APPLICATION FOR MODIFICATION ASSESSMENT REPORT

Application Number:	Mod2021/0647
Responsible Officer:	Penny Wood
Land to be developed (Address):	Lot 101 DP 1110110, 96 - 97 North Steyne MANLY NSW 2095
Proposed Development:	Modification of Development Consent DA 272/2017 for Alterations and additions to an existing Residential Flat Building
Zoning:	Manly LEP2013 - Land zoned R3 Medium Density Residential
Development Permissible:	Yes
Existing Use Rights:	No
Consent Authority:	Northern Beaches Council
Delegation Level:	NBLPP
Land and Environment Court Action:	No
Owner:	Cecil George Koutsos Isabel Brenda Koutsos
Applicant:	Squillace Architects

Image 1: Roof plan indicating setbacks from mechanical plant screening to eastern, western, northern and southern boundaries.

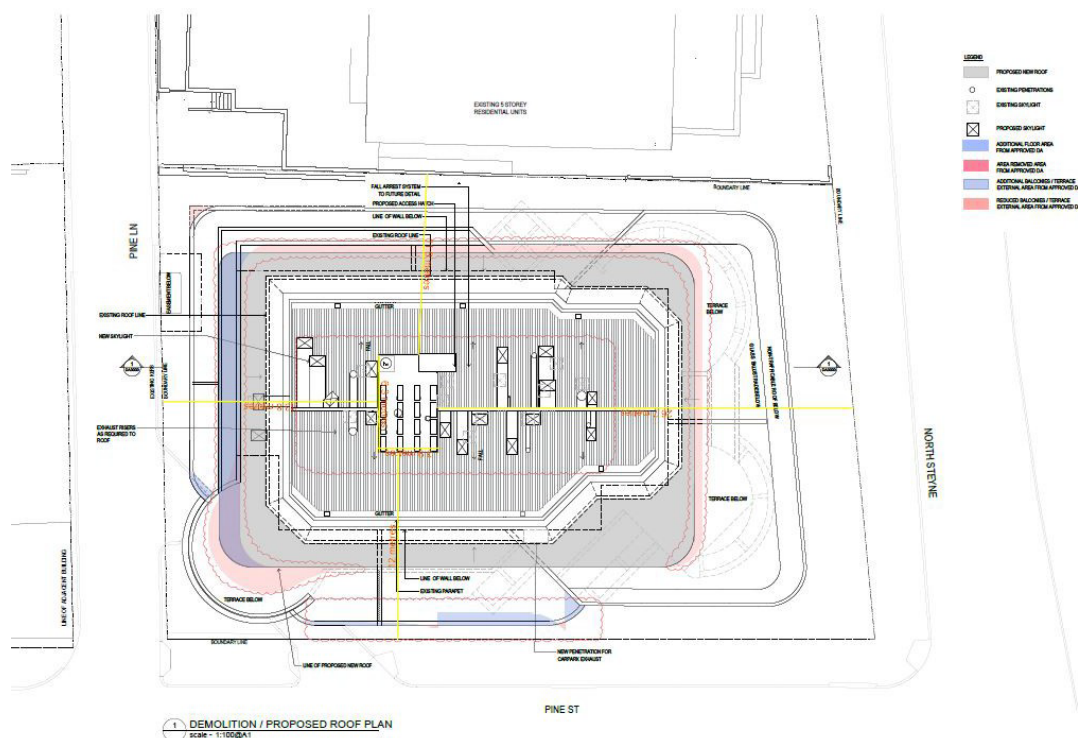
The application proposes mechanical plant with acoustic screening on the roof of the subject residential flat building. The mechanical plant and screening will measure a maximum height of 1.55m resulting in an overall building height of 16.45m (RL22.41). A condition is imposed in the consent to ensure that the highest point of the development does not exceed RL22.41 with the louvred screening in association

with the mechanical plant will not measure greater than 1.55m above the approved top of roof (RL20.79). Whilst the plant and screening exceeds the maximum 13.0m LEP height control prescribed for the site, the mechanical plant and screening will not be visible from a public place, with generous setbacks to the eastern, western, southern and northern boundaries. The residential flat building currently measures 14.9m in height with the previous application (DA272/2017) approving amendments to the roof form.

The non-compliant mechanical plant and screening is confined to a central portion of the roof and is considered to have a minimal impact towards the amenity of the surrounding properties and the appearance of the building when viewed from a public space.

to the development. The mechanical plant and screening will measure 3.9m in depth (east to west) and 6.3m in length (north to south). The screening is setback 13.8m from Pine Lane, 26.7m to North Steyne, 12m to Pine Street and 11.6m to northern boundary. The proposed works will not impact on the design of the building in that an articulated facade is maintained.

- The mechanical plant louvred screening is limited to a maximum of 1.55m in height above the approved top of the roof (RL20.79) and is not to exceed an overall height greater than RL22.34.
- Delete the extension to the ground floor terrace for Unit 2 and Unit 3.
- Delete the proposed wall along the eastern boundary.
